MEMORANDUM

PROPOSAL: RHYDDHAU AMOD 3 (CYNLLUN RHEOLI ADEILADU) CANIATÂD CYNLLUNIO P/2023 /0072 / DISCHARGE OF CONDITION 3 (CONSTRUCTION MANAGMENT PLAN) OF PLANNING PERMISSION P/2023 /0072

LOCATION: WREXHAM COUNTY MUSEUM, REGENT STREET, WREXHAM, LL11 1RB

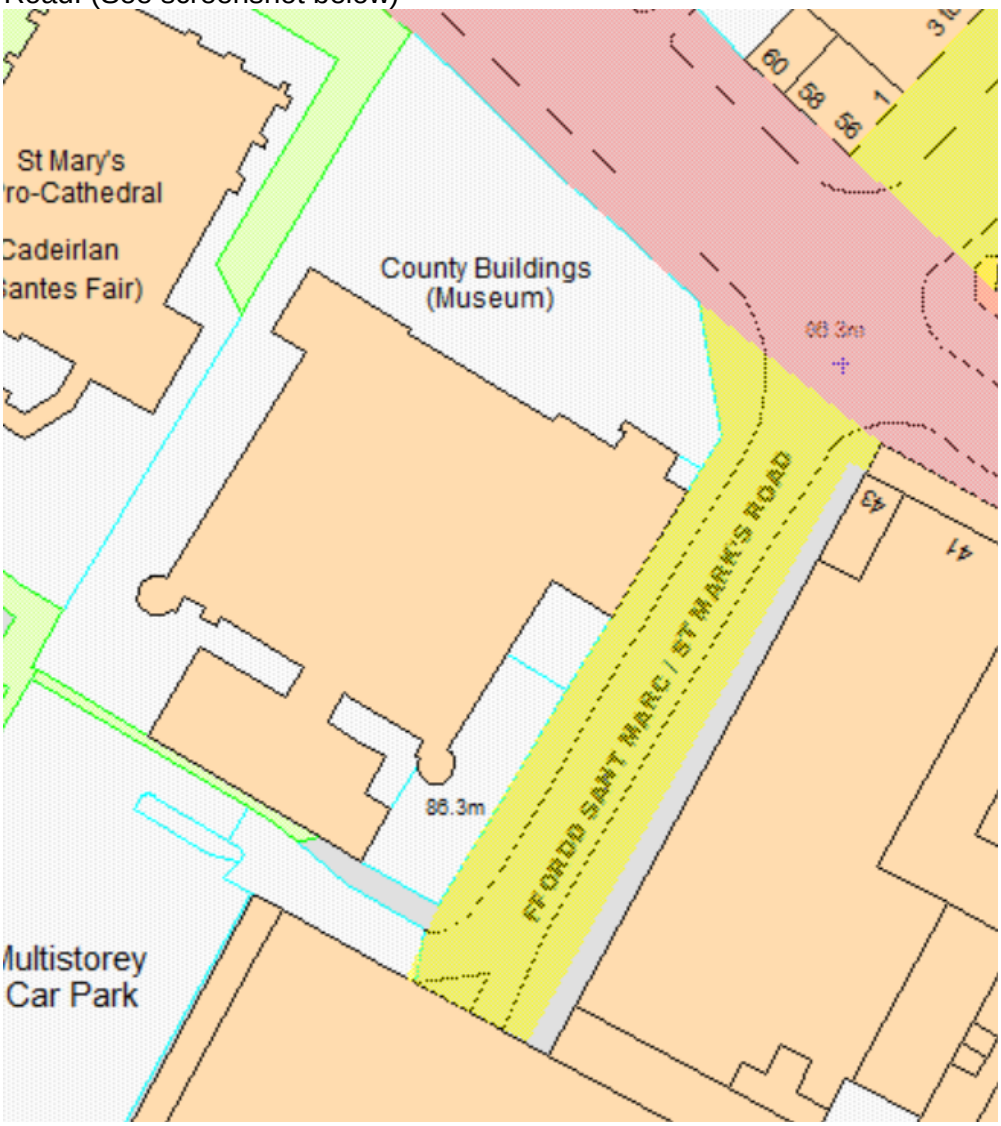
- There is a site plan showing Office/Welfare/Compound and Material laydown area. There is an area shaded light green for vehicle offloading that is on the adopted highway of St Marks

Road. (See screenshot below)

Use of this area for unloading will require the prior permission of WCBC's highways department. The applicant is required to contact highwayroadworks@wrexham.co.uk at their earliest convenience in advance of arranging any delivery. There appears adequate space for unloading, subject to arranging the necessary permits and demonstrating competent banksmen will be supervising the works, and all the necessary insurances are in place.
